Re: 6 The Dales, Langho, Blackburn BB6 8BW  
Planning Application No: 3/2024/0183

We are writing to object to the above application.

**Fig 5 – Submitted Plans**

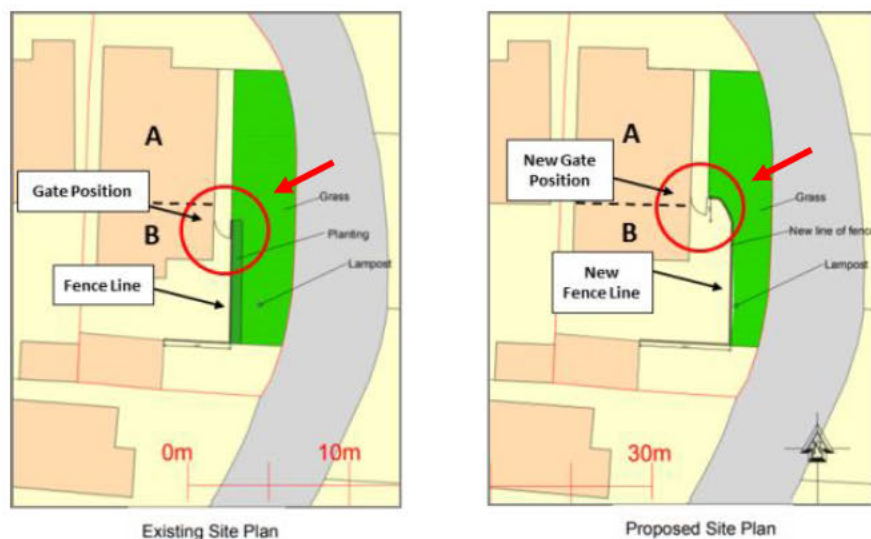
However, the Site Plan submitted to RVBC shows the 'existing' fence and gate mid-way along the wall of the rear extension; with the new gate drawn level with the back of the main dwelling, see Fig 5.

**Fig 6 - Detailed Fence Panel Drawings**

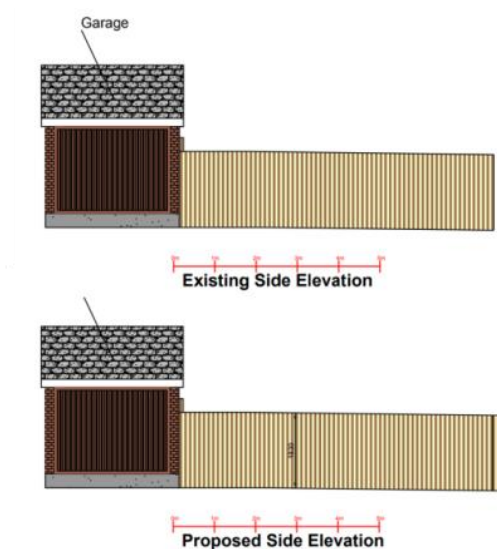
The detailed fence panel drawings are also incorrect, and do not reflect the position, or length, of the existing fence line at the property.

**Fig 7 - Boundary Line**

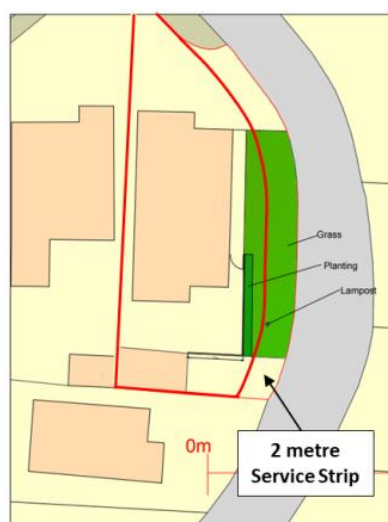
The boundary line shown on the Site Plan submitted to RVBC is also incorrect. It shows the boundary running alongside the road; but as previously noted, there is a 2m Service Strip immediately adjacent to the road which the property owner does not own, and cannot build on.

**Fig 8 - Approx. Distance to Service Strip (Narrowest Point)**

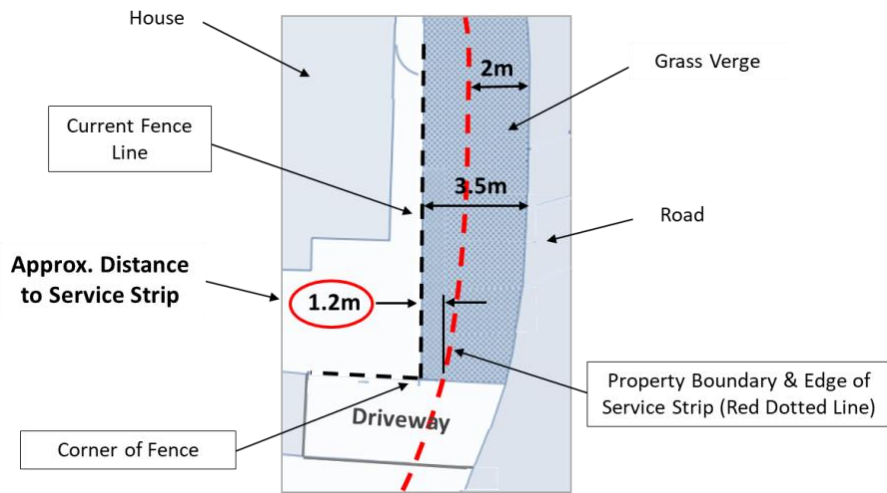
At its narrowest point the Service Strip is 1.2m away from the fence. Moving the fence nearer to the road by 1.5m means part of the fence will be in the Service Strip Area.

And the title deed for the property prohibits the construction of fences, walls or other structures within this area:

4. Not to erect or plant or permit to be erected or planted any gates fences walls structures shrubs trees or hedges on any part of the Service Areas

Fig 10 - Trees & Shrubs

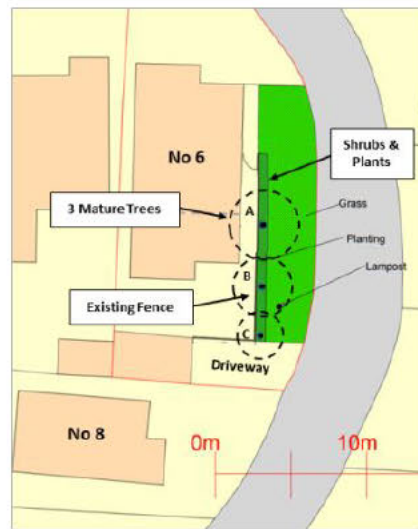
The planning application refers to the removal of 3 trees from the fence line; however I believe the property owner now only wants to remove one tree (A); but this is not reflected in the planning application.

**Fig 16 - Building Lines (Nos.6 & 8)**

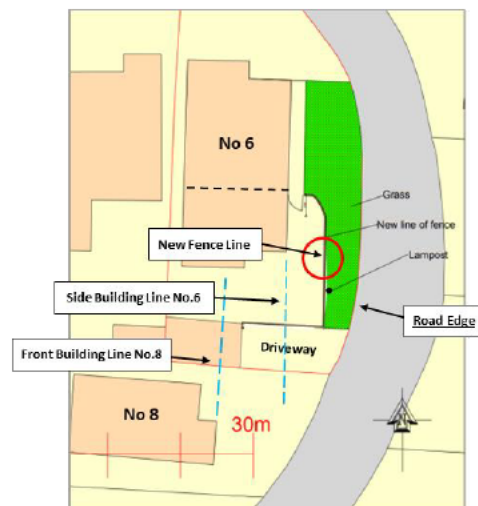
The following sketch shows the front and side Building Lines of Properties Nos.6 & 8 (dotted blue lines). It also shows the abutting road on the right. As the fence will be constructed to the right of these lines, I believe it contravenes the title deeds.

**Fig 18 – Existing & Proposed Fence**

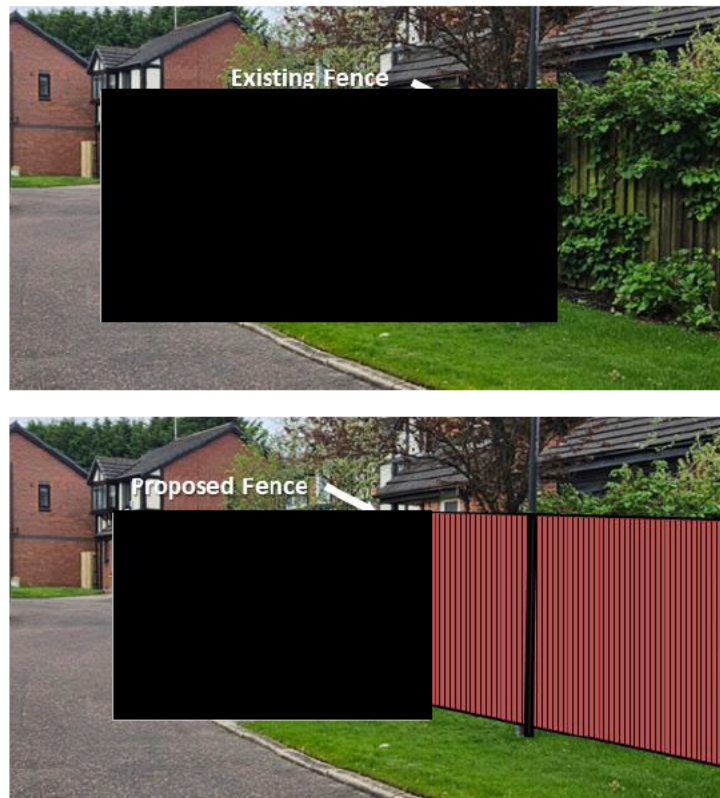
Moving the fence 1.5m closer to the road would also create a blind spot for road users, and anyone using the driveway adjacent to the property, see Fig 18.
